**WASHINGTON CITY
PLANNING COMMISSION MEETING
STAFF REVIEW**

AGENDA ITEM:	4a
HEARING DATE:	December 06, 2023
ACTION REQUESTED:	Amended Preliminary Plat approval for the Burke Springs Phase-3 Subdivision, located at approximately Creek side Court and Rimview Drive
APPLICANT:	Short Term Investments LLC
OWNER:	Short Term Investments LLC
ENGINEER:	Kelvin Smith, Civil Science
REVIEWED BY:	Eldon Gibb, City Planner
RECOMMENDATION:	Recommend approval with conditions

**PROJECT FLOW CARD****PP-23-0010 Burke Springs****Phase 3 Amended Preliminary Plat****MEETING DATE****11/15/23 PC 12/13/23 CC**

See proposed
changes in Red

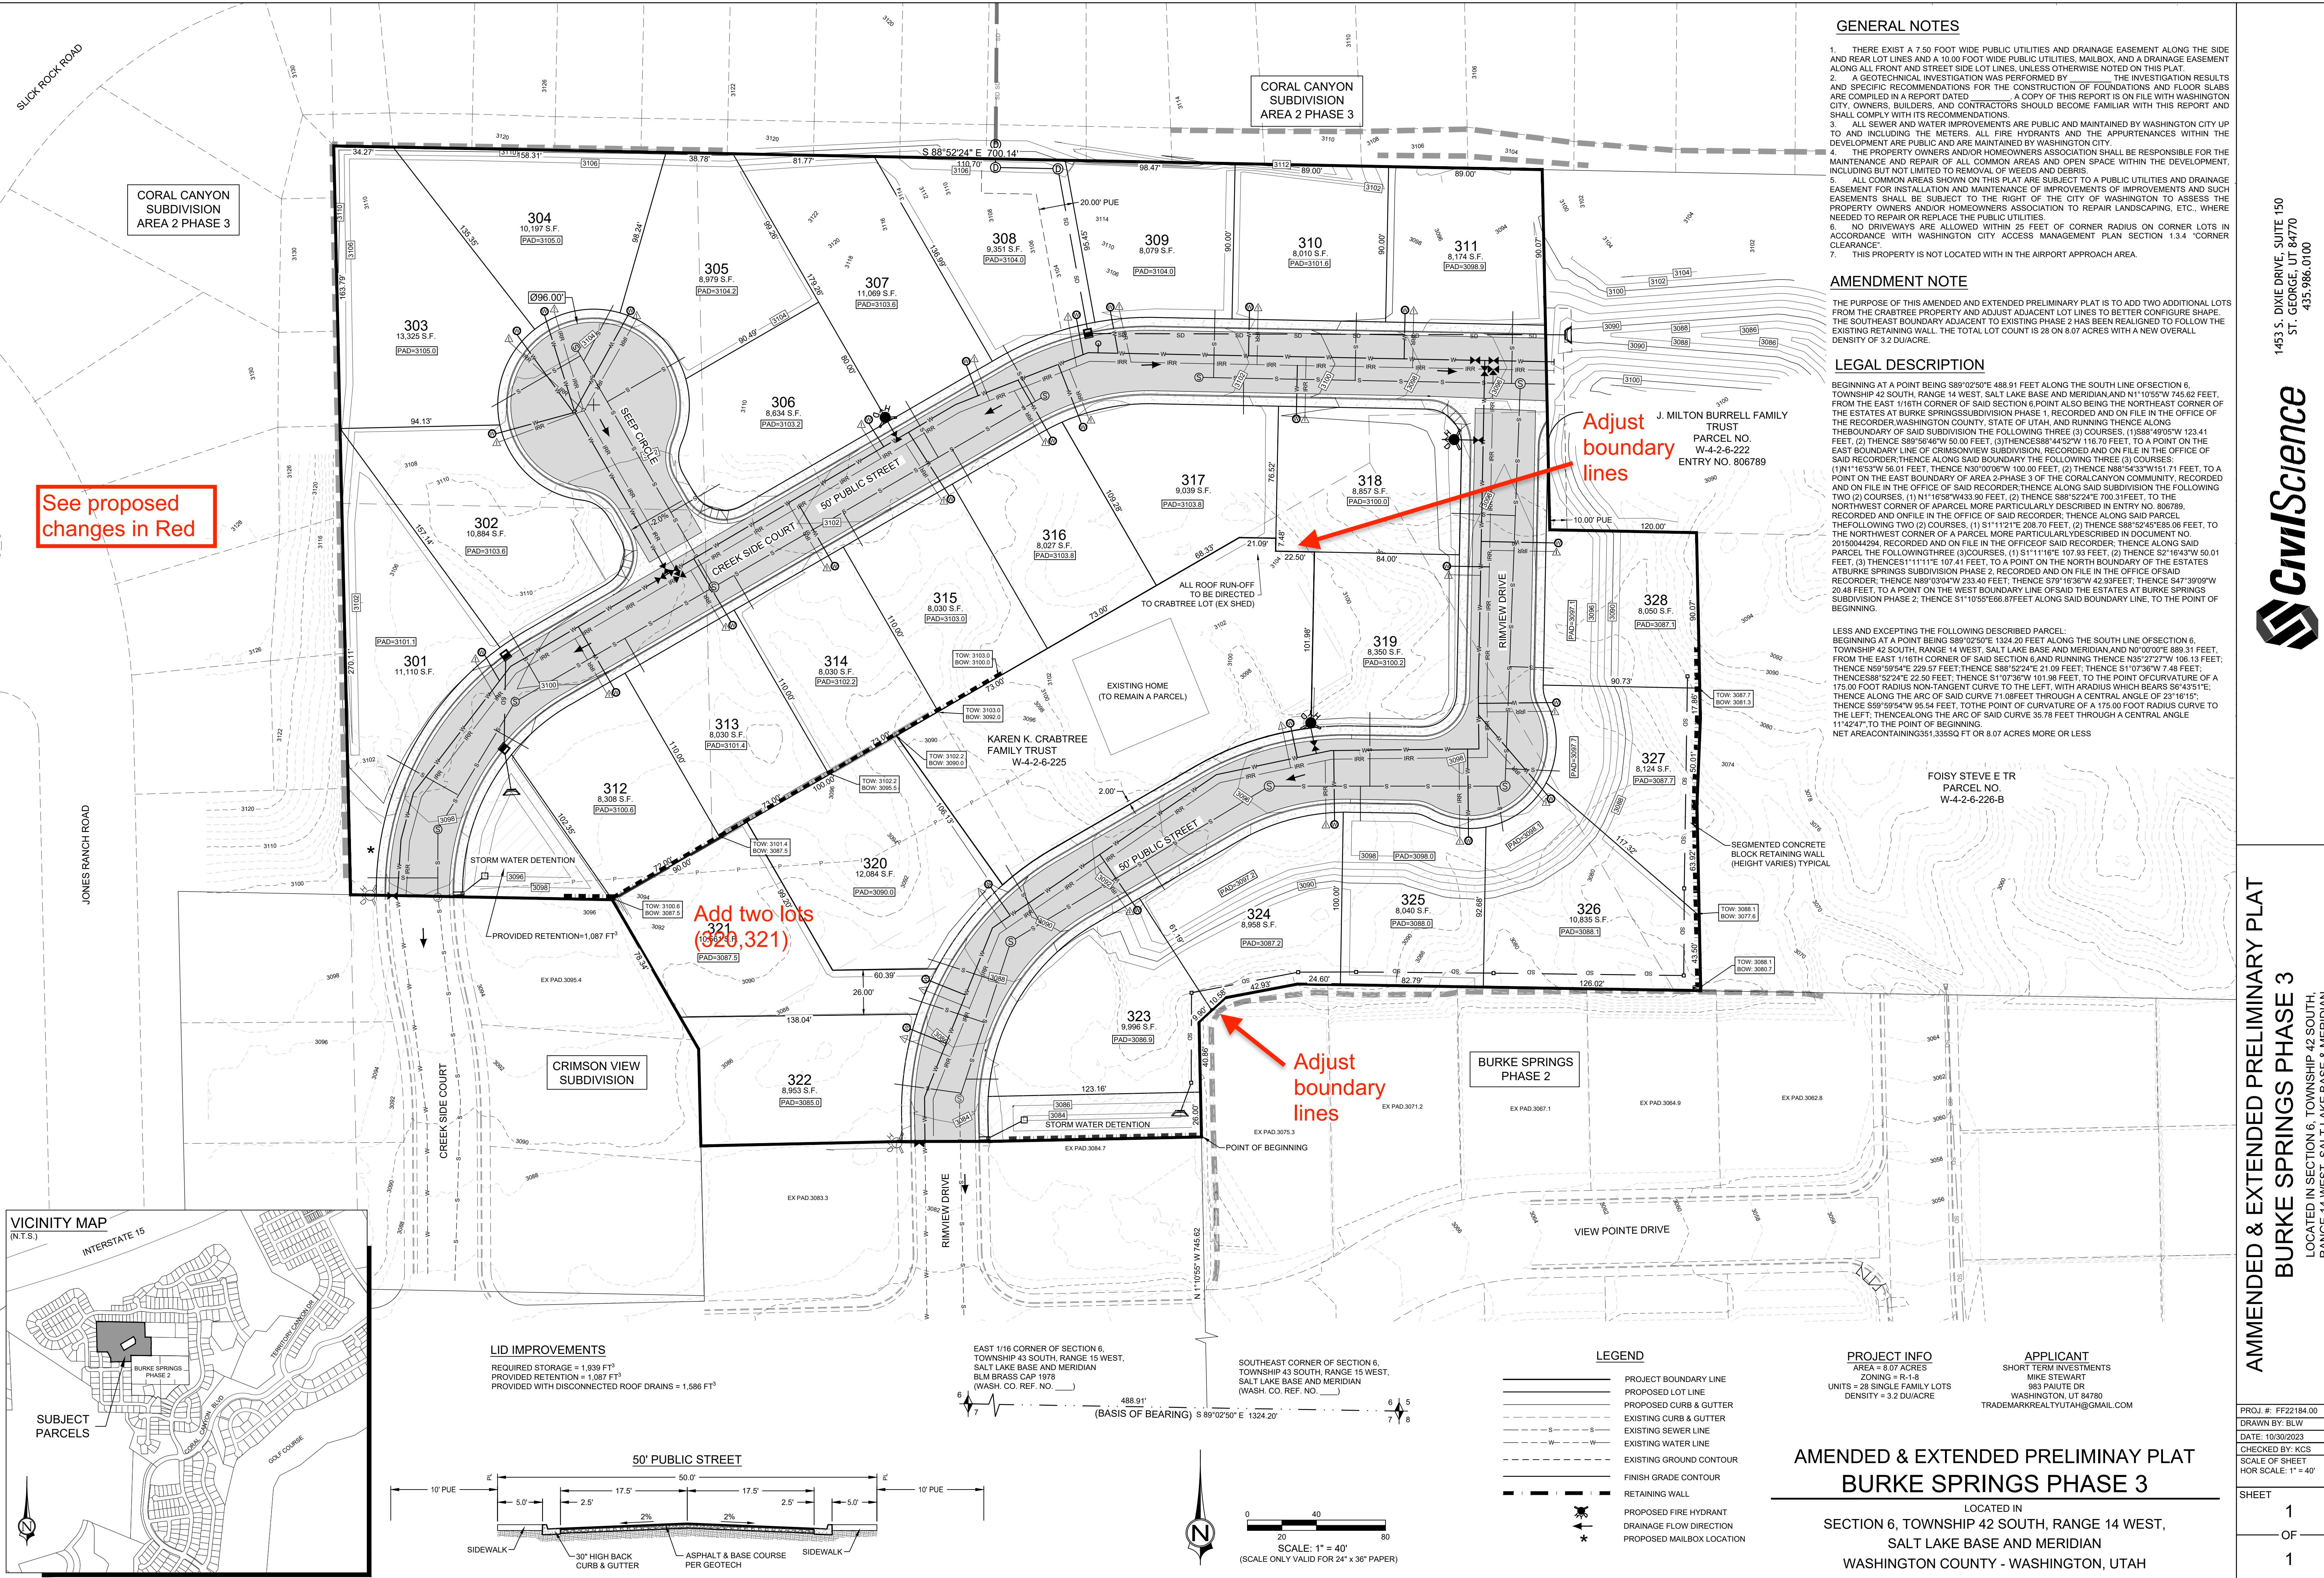
Planning	Reviewed no concerns EG	
Hillside	NA	
Public Works	If approved we will need to update the construction drawings for the additional lots and other changes. Grading and drainage issues on Burrell Family trust land have already been noted during initial CD plan review and the developer is working with the trust to obtain easements. CD's will not be approved until issue is resolved but no problem moving preliminary plat forward. Reviewed and approved with conditions	
Engineer	Reviewed, no concern	
Fire Dept.	Reviewed and have no concerns at this time	
Parks/Trails	Reviewed. No concerns.	
Building dept	Reviewed and have no concerns	
Washington Power	Reviewed and approved with conditions- Needs to revisit construction drawings for new lots added	
Dixie Power	NA	
Economic Dev.	Reviewed. No concerns. Residential rooftops in this area help support and stimulate planned commercial development for the nearby general planned business development. RH

1. A preliminary and final drainage study and grading and drainage plan shall be submitted for review and approval prior to moving dirt. Development of the site shall comply with the recommendations of the geotechnical study and drainage study, and improvements for drainage and detention shall be approved by the Public Works Department.

4. The construction drawings shall adequately address prevention of nuisance storm water drainage across lots. If retaining walls are utilized to prevent cross-lot drainage, the developer shall be responsible for installing said retaining walls.

LIBERTY LANE PARTIAL AMENDMENT "A" (AMENDING LOTS 1 & 2)

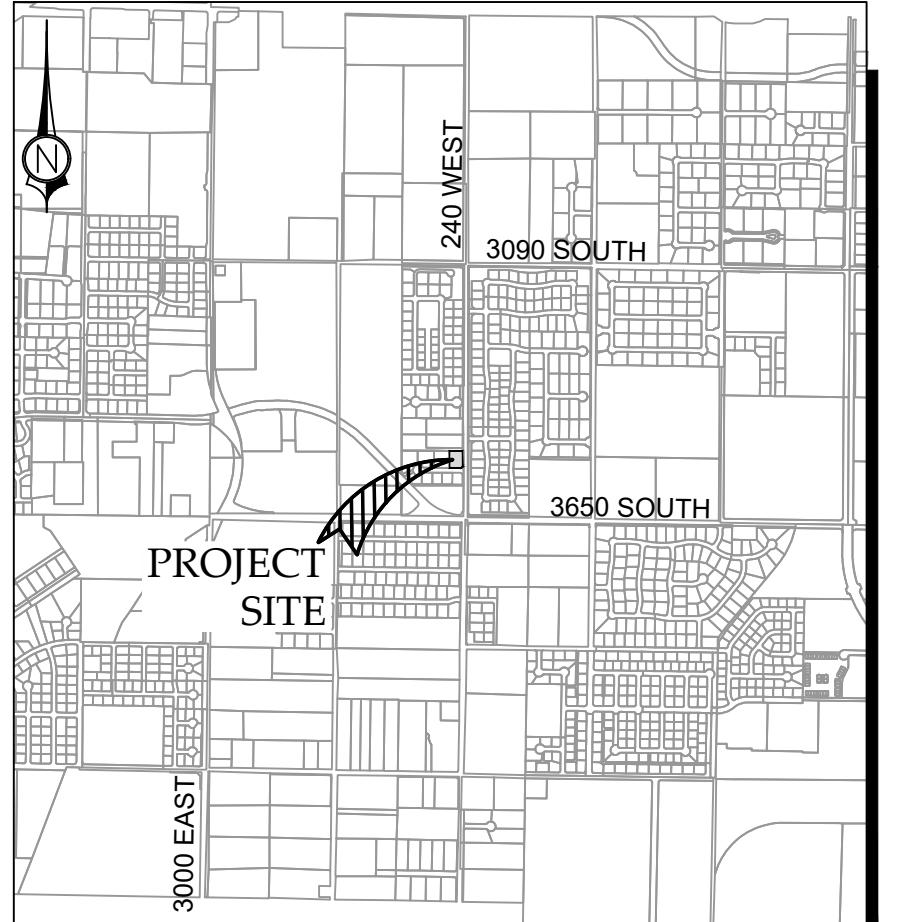
Planning	Reviewed. OK to move forward	
Hillside	NA	
Public Works	Reviewed - Recommend approve with condition that unused water, irrigation and sewer services be capped by owner prior to public works sign-off of final plat	
Engineer	Reviewed no concern PM	
Fire Dept.	NA	
Parks/Trails	Reviewed. No concerns.	
Building dept	Reviewed, no comments	
Washington Power	NA	
Dixie Power	Reviewed. No concerns. CR	
Economic Dev.	Reviewed. No concerns.	
Administrative	NA

Proposed change is to combine lots 1 and 2

RE: Exit 13 General Plan Amendment Application, Parcels W-5-2-11-141 & W-5-2-1-122

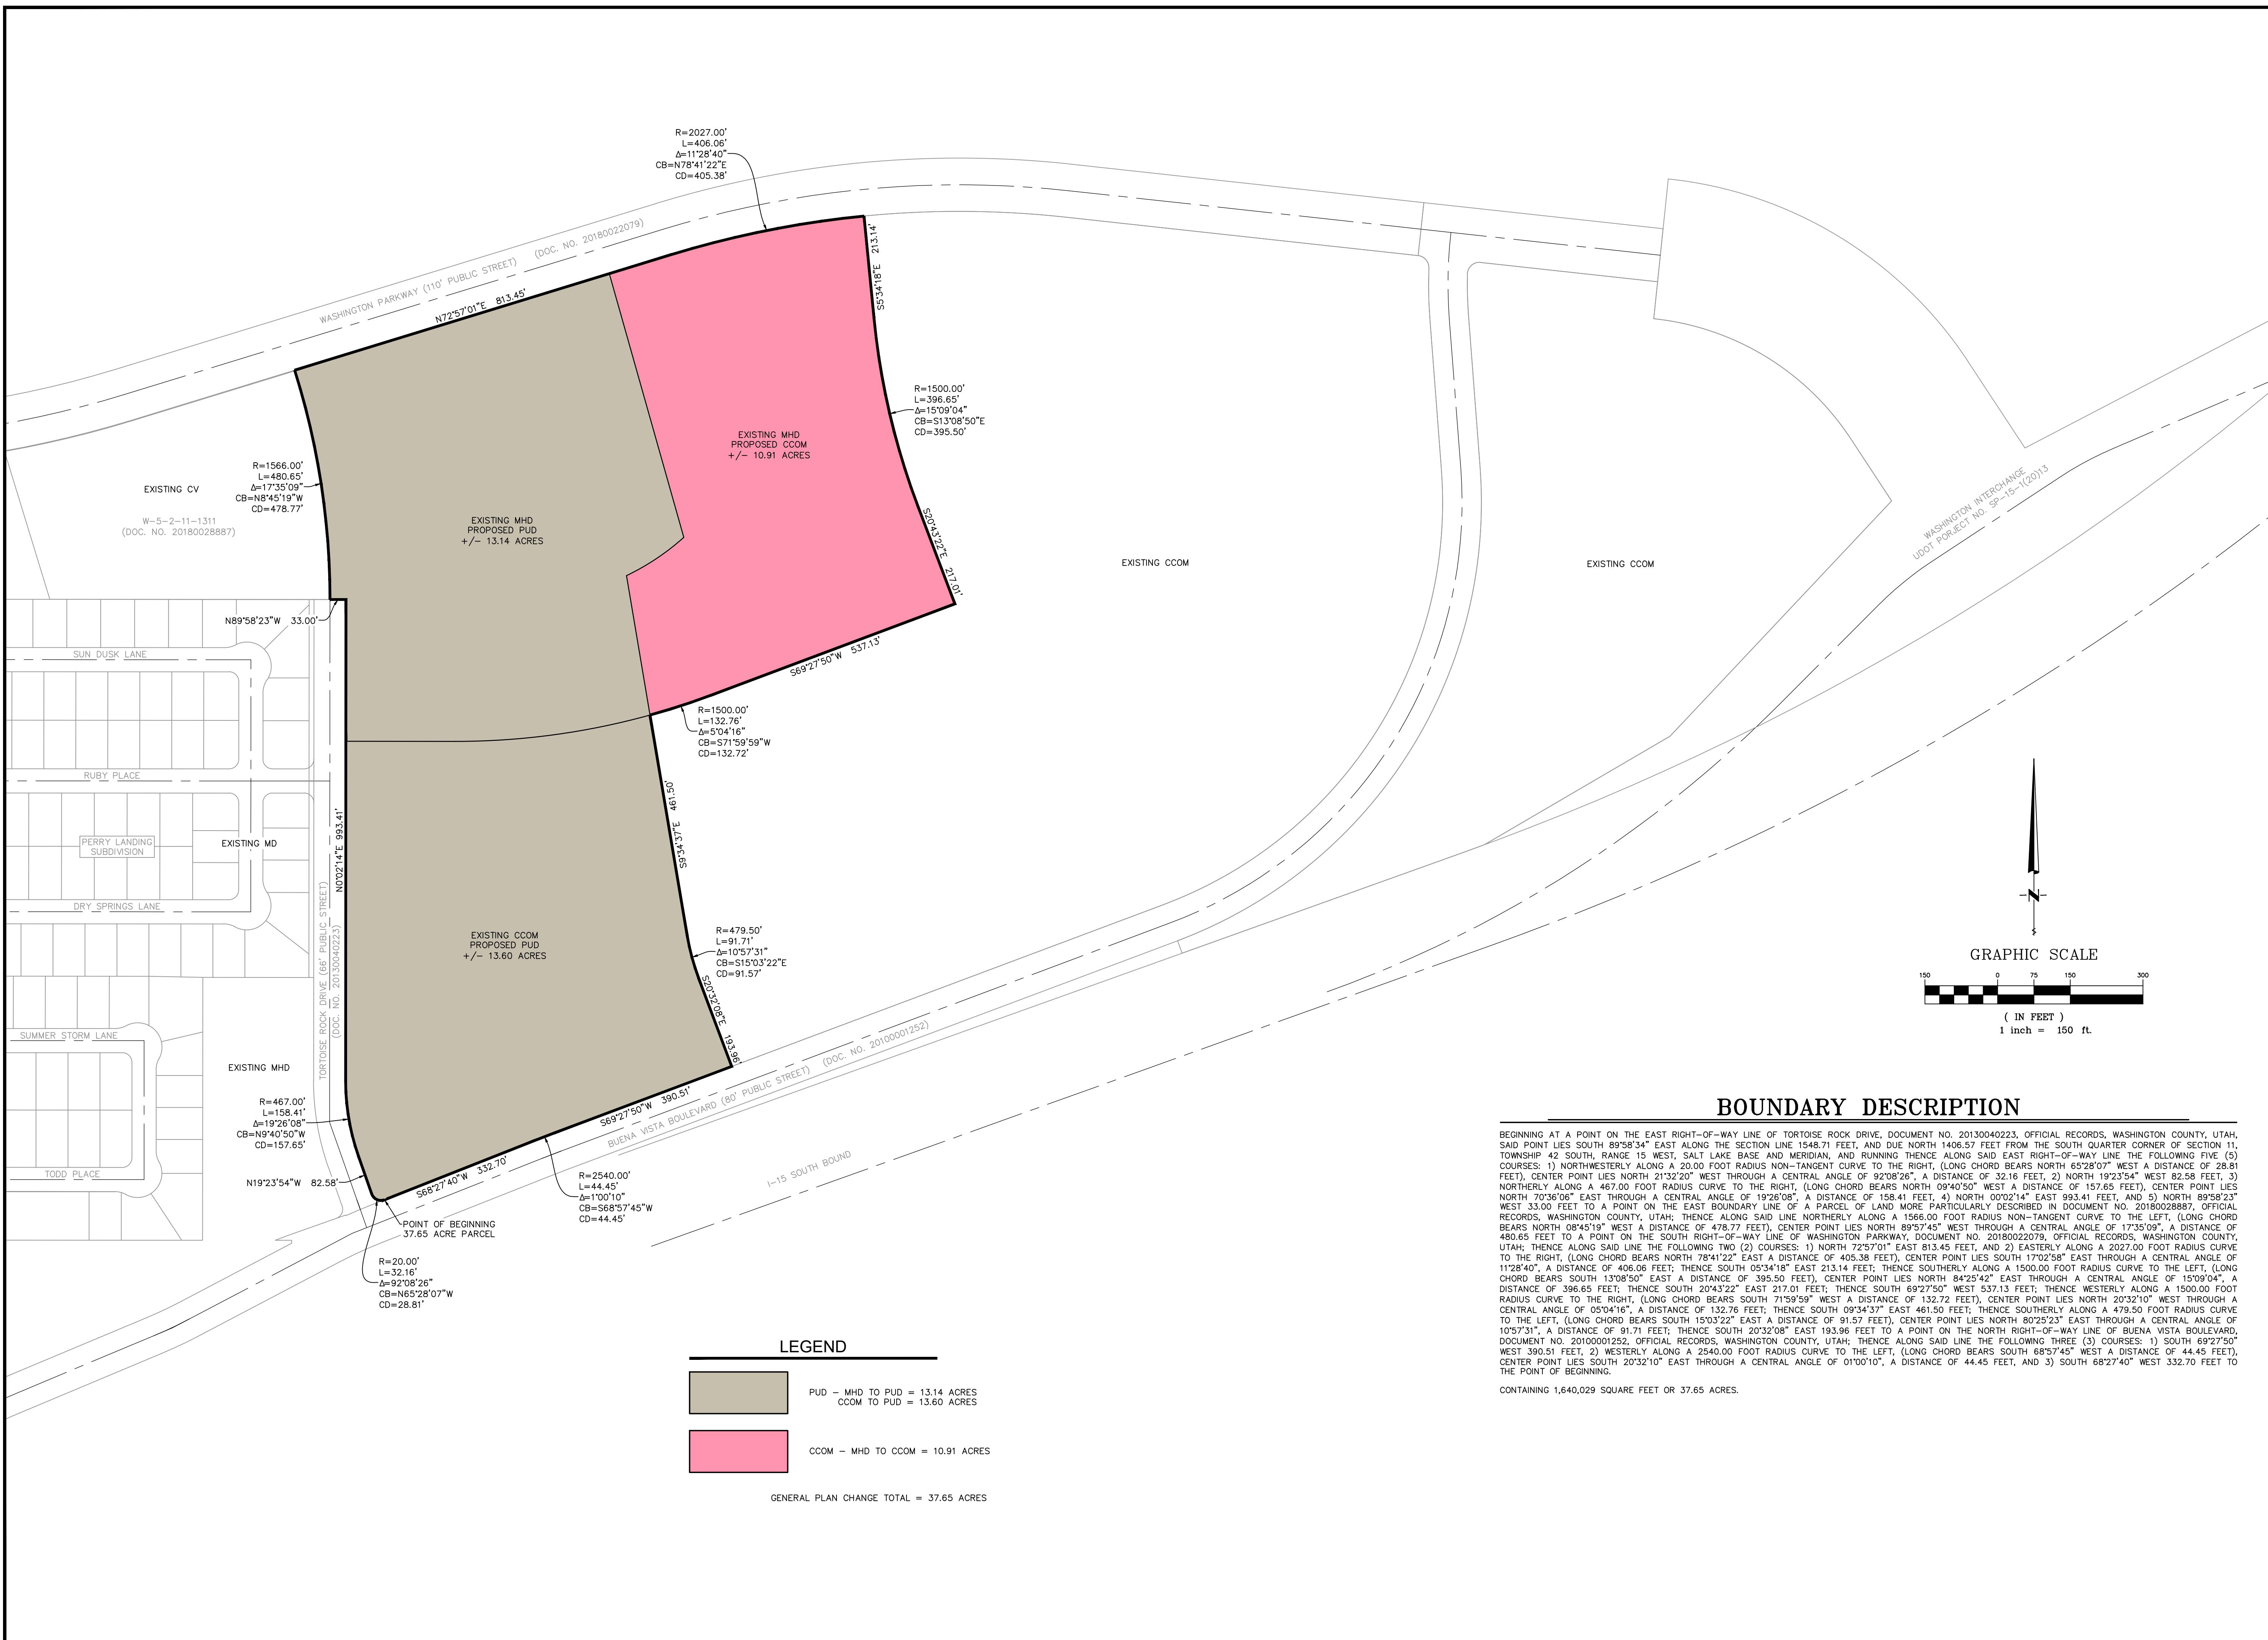
Planning	Reviewed. OK to move forward EG	
Hillside	NA	
Public Works	Reviewed no concern JH	
Engineer	Reviewed, no concern	
Fire Dept.	NA	
Parks/Trails	Reviewed. No concerns. PW	
Building dept	Reviewed, no comments GC	
Washington Power	Reviewed, no concerns at this time TS/RH	
Dixie Power	NA	
Economic Dev.	PUD should prioritize commercial development over additional housing. This area represents one of the few remaining commercial areas of significant size in Washington City. It would be counter productive to the city's economic development strategy to allow conversion of these lands to residential without significant commercial development. RH	
Administrative	NA

With this application, the applicant desires to amend the Washington City General Plan. We respectfully request that the designations change as follows: 13.88 Acres from MHD to PUD, 12.89 Acres from CCOM to PUD, and 12.01 Acres from MHD to CCOM, as shown on the exhibit provided. The current General Plan designation of CCOM will remain on the balance of the parcels.
